Base Load Power Hub (BLPH)

HAZID Close Out Report

Document Number: 123A90-DDL-SAF-RE-30010

The objective of the present document is to provide a formal close out record for all actions that have been responded to and signed-off. This includes both FEED and EPC Actions coming from HAZID workshops.

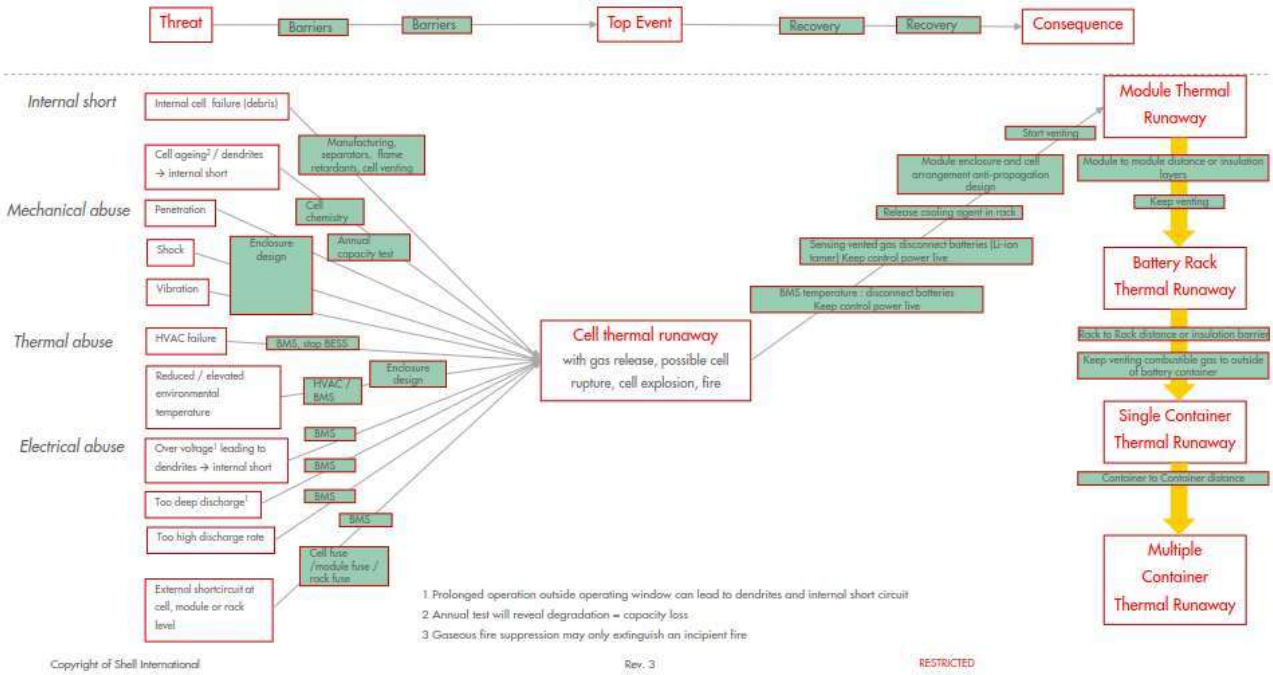
Action No:	**0001**	**Rev:**	1
Action Title:	**HAZID Study Actions**	**Date:**	25/03/2023
Ref. Doc:	K559-2254-SE-REP-001		
Title:	BLPH HAZID Study		
Node:	1: Electrical System		
Reference Drawings:	N/A		
Parameter	H-03.05b	**Deviation**	Hydrogen
Cause:	Thermal runaway within BESS.		
Consequence:	Potential explosive atmosphere. Asset damage. Potential fatalities.		
Safeguards:	Fire & gas detection philosophy will be developed during FEED phase.		
Action:	1 Shell to consider providing thermal runaway bow-tie information to KBR.		
RESPONSE:	**Responsible Discipline: Shell** Bow-Tie provided showing cell thermal runaway		
Attachments:	None

Threat
Barriers
Barriers
Top Event
Recovery
Recovery
Consequence
Internal short
Internal cell failure (debris)
Cell ageing² / dendrites → internal short
Manufacturing, separators, flame retardants, cell venting
Mechanical abuse
Penetration
Cell chemistry
Shock
Enclosure design
Annual capacity test
Vibration
Thermal abuse
HVAC failure
BMS, stop BESS
Reduced / elevated environmental temperature
HVAC / BMS
Enclosure design
Electrical abuse
Over voltage¹ leading to dendrites → internal short
BMS
Too deep discharge¹
BMS
Too high discharge rate
BMS
Cell fuse / module fuse / rack fuse
External shortcircuit at cell, module or rack level
Cell thermal runaway
with gas release, possible cell rupture, cell explosion, fire
Start venting
Module enclosure and cell arrangement anti-propagation design
Release cooling agent in rack
Sensing vented gas disconnect batteries (Li-ion tamer) Keep control power live
BMS temperature : disconnect batteries Keep control power live

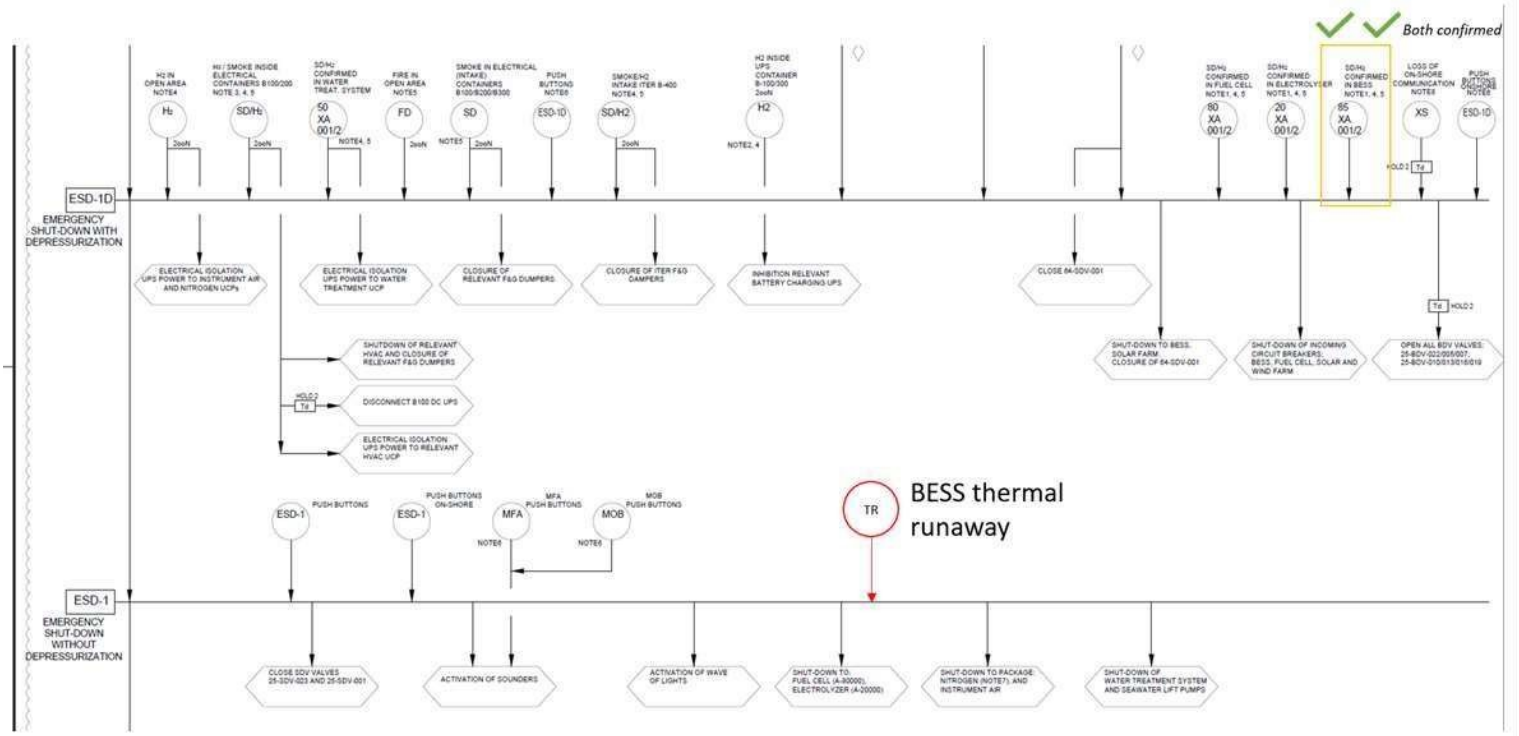
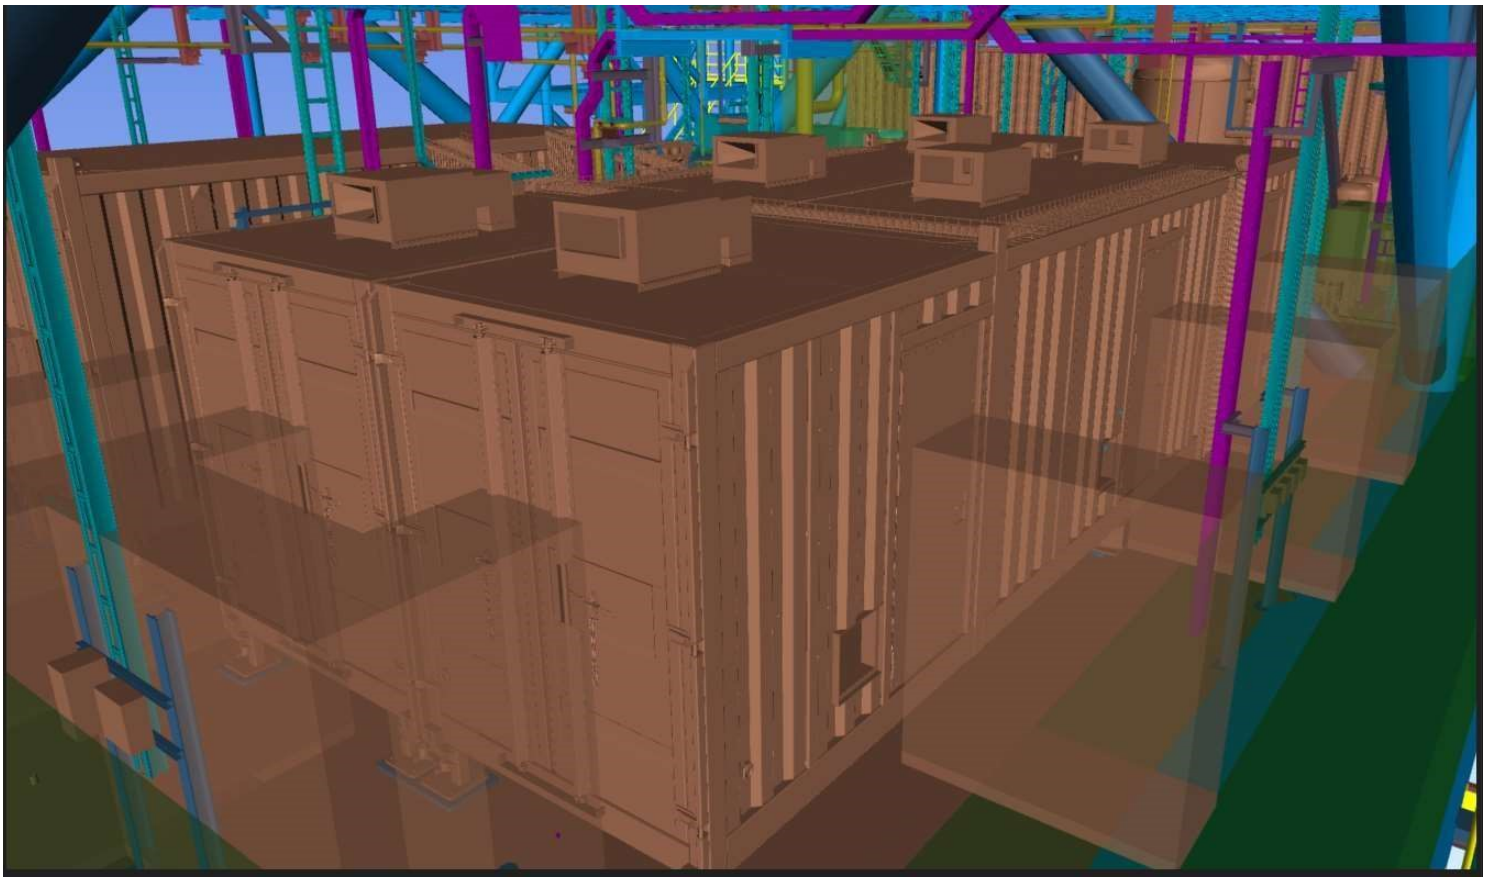
Action Title: **Ref. Doc.**	**HAZID Study Actions** K559-2254-SE-REP-001
Item No.	1
Cause:	Hydrogen released from BESS.
Consequence:	Potential explosive atmosphere. Asset damage.
Safeguards:	
Actions:	Update layout to show vent from BESS.
Assigned Respondent (By)	ROSETTI Piping & Layouts Engineer
RESPONSE	According with the mail attached, no vent from BESS will be provided. The Potential emergency exhaust of H2 shall be released on the lower deck with the following mitigation to manage the risk of accumulation. 1.Exhaust openings have been provided above BESS containers (see extract from 3D model attached) 2.Areas identified for accumulation shall be fitted with a H2 detector (1 per accumulation area. See 123A90-DDL-SAF-DL-30027 attached). These shall be voted in alignment with the platform FGS philosophy i.e. 2ooN
Attachments:	
Issue Date

Thanks for the collaborative discussion last week on the way forward regarding the BESS vent.

Summary and agreed way forward:

The emergency exhaust shall be released on the lower deck with the following mitigation to manage the risk of accumulation.

1. Areas for potential accumulation above BESS containers to be reviewed and identified
2. Areas identified for accumulation shall be fitted with a H2 detector (1 per accumulation area). These shall be voted in alignment with the platform FGS philosophy i.e. 2ooN and shall take the execute action as currently outlined in the process safety block diagram.

In addition, there will be a FGS hardwire signal from the BESS, "confirmed thermal runaway in BESS" as outline below. Critically, AUX power to the BESS shall remain active in this case.

TITLE :
BLPH PIPING AND INSTRUMENTATION DIAGRAM
WATER DISPOSAL SHEET 1

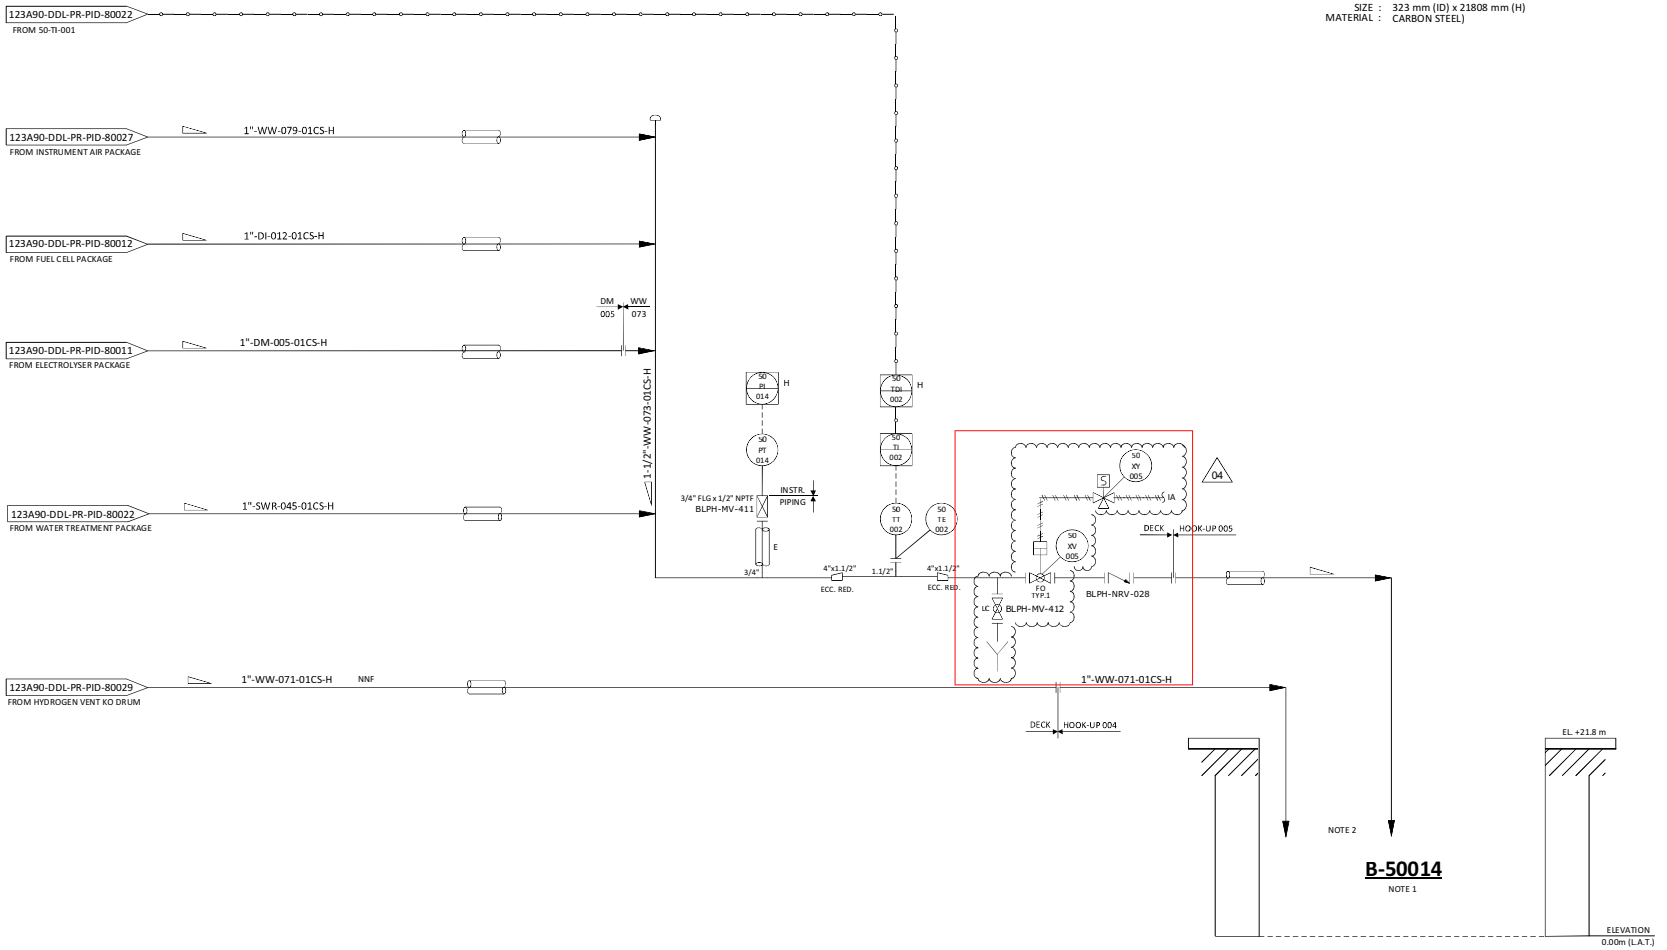
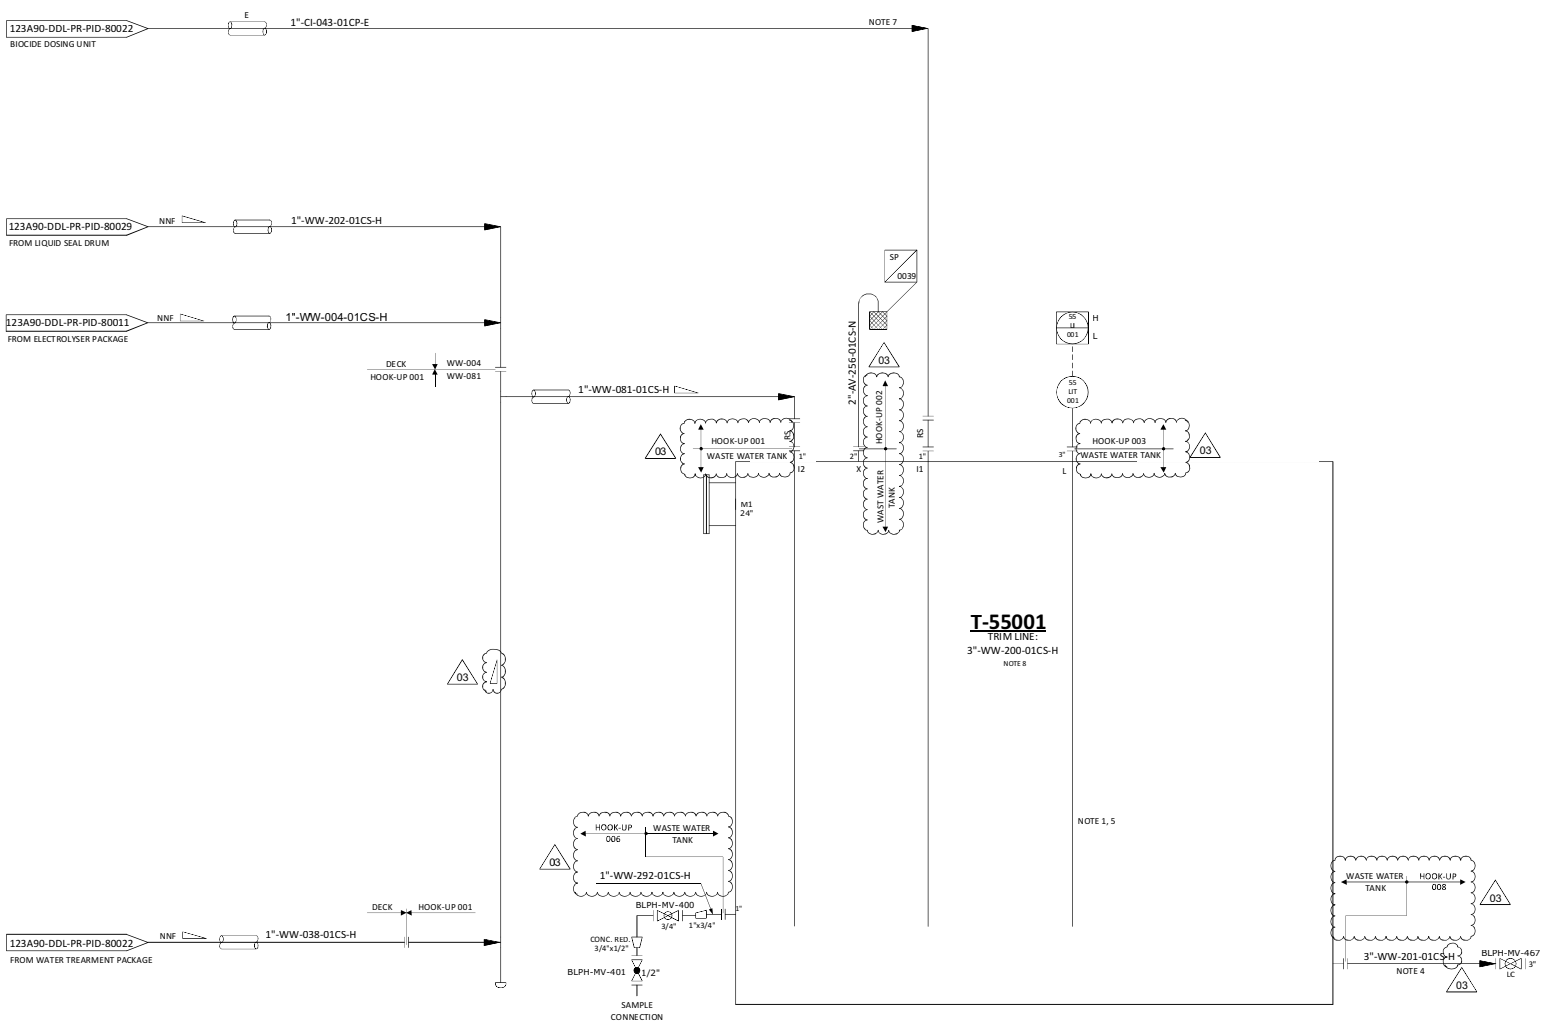
Action Title: **Ref. Doc.**	**HAZID Study Actions** K559-2254-SE-REP-001
Item No.	6
Cause:	Discharge brine from process.
Consequence:	Impact marine life.
Safeguards:	
Actions:	Confirm compliance with permitted discharges from facility & water decree from RWS.
Assigned Respondent (By)	ROSETTI Technical Safety Engineer
RESPONSE	In compliance with water decree the wastewater flow discharged into the surface water of the North Sea are the ones as per following table:

Boat landing access BLPH

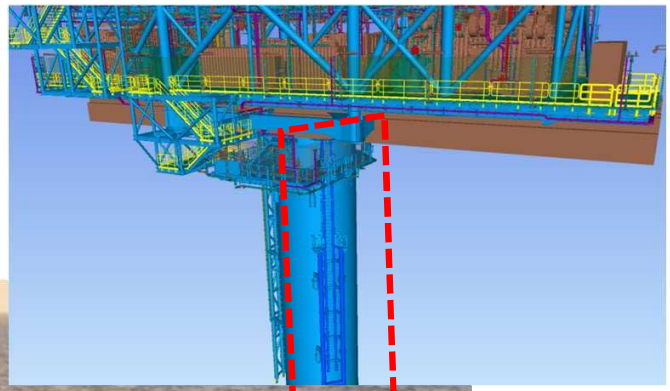
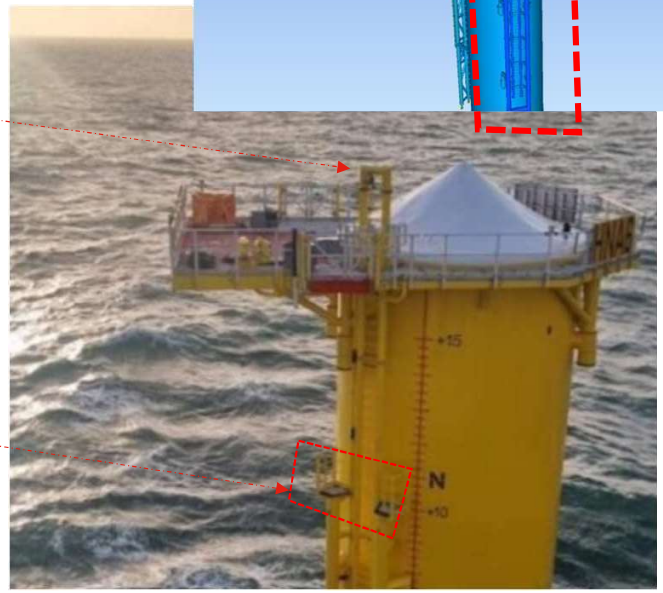
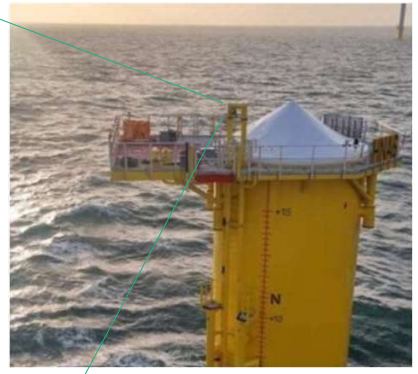
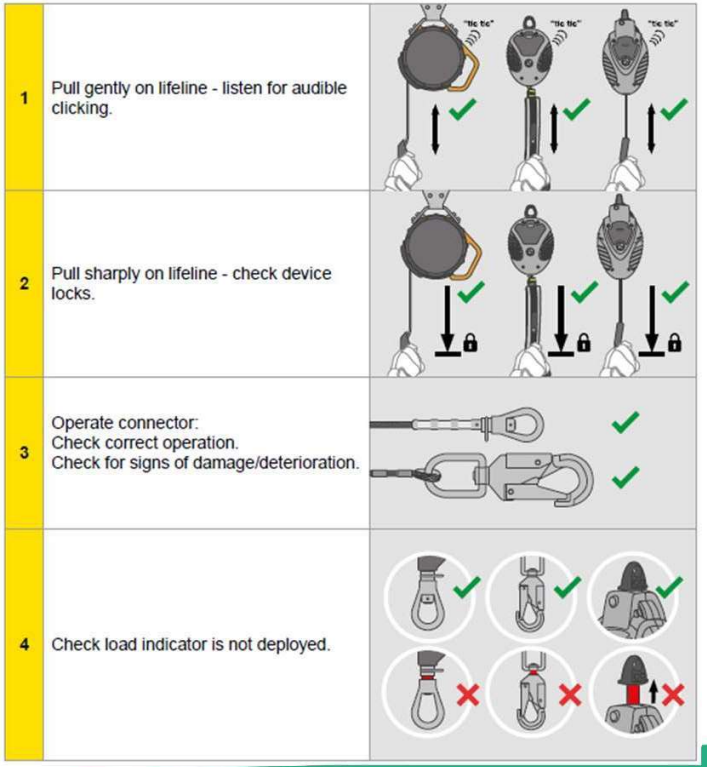
Action Title: **Ref. Doc.**	**HAZID Study Actions** K559-2254-SE-REP-001
Item No.	10
Cause:	Transfer from boat, Flotel to offshore platform. Transfer of personnel from boat to asset. (made worse by fog)
Consequence:	Personnel injury / fatality.
Safeguards:	Procedures in place for transfer of personnel onto asset.
Actions:	Crosswind to share procedures for personnel transfer.
Assigned Respondent (By)	CROSSWIND
RESPONSE	See attached document CW Innovations BLPH Offshore transfe
Attachments:	
Issue Date (dd/mm/yy)

EWOO follows the G+ OFFSHORE WIND GOOD PRACTICE GUIDELINES WIND FARM TRANSFER. The likelihood of unplanned water entry, whilst undertaking a standard CTV transfer, is extremely low with the existing mitigating measures. If a person does fall in the water, the time it takes to recover a person is short.

During a CTV transfer it is no longer required to wear an immersion suit when the seawater temperature is below 10°C or during hours of darkness when following the correct mitigating measures.

1. The transferee must hook on to and off from the SRL at the CTV to be protected from falling into the sea during the transfer.
2. The CTV vessel crew must be trained and competent to quickly recover a person from the sea. The time taken to remove a casualty from the sea should ideally be less than 15 minutes.

7. During the hours of darkness the CTV will provide:
   a. Sufficient (flood) lighting to illuminate the boat landing
   b. A (search) light to illuminate possible incoming waves.

A1 | DRAWING NO. 1724000887-MAC-DA-00003 | SHEET 001 | REV. 01

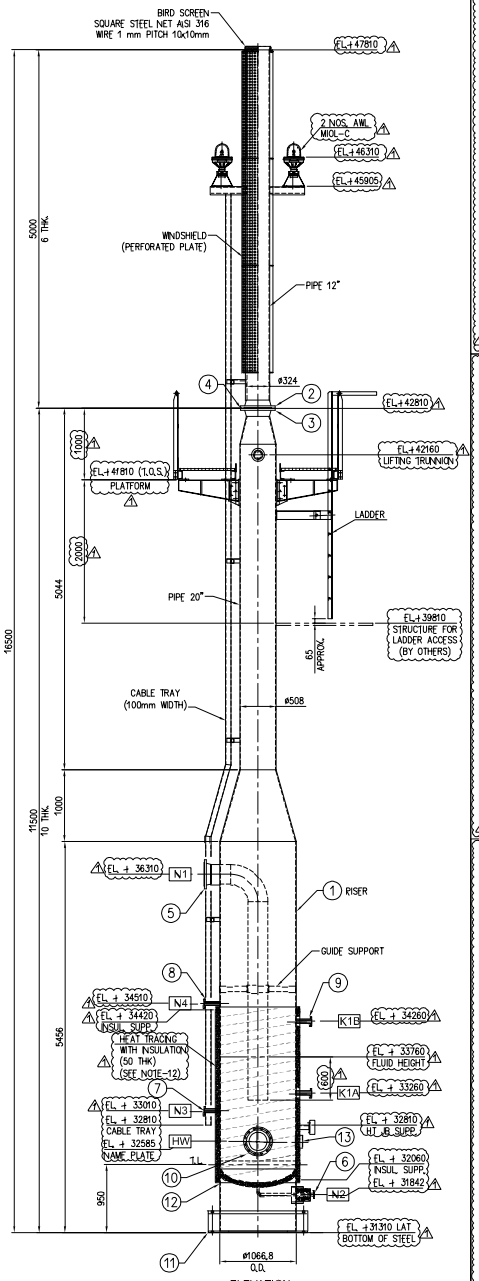
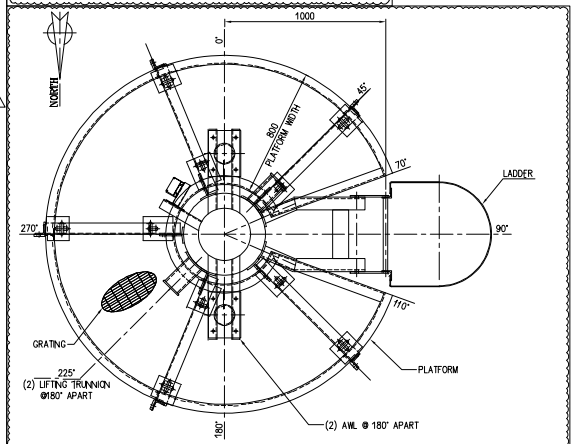
Action Title: **Ref. Doc.**	**HAZID Study Actions** K559-2254-SE-REP-001
Item No.	13
Cause:	Potential oxygen rich atmosphere around vents
Consequence:	Potential impact on passing birds
Safeguards:	
Actions:	Clarify regulatory requirements for disposal of dead birds/ biodiversity of existing area. Environmental impact assessment to cover impact to birds.
Assigned Respondent (By)	CROSSWIND
RESPONSE	If dead birds are found the the BLPH , they will be disposed as per Dutch Industry stadnard Nogepa N.64
Attachments:	
Issue Date
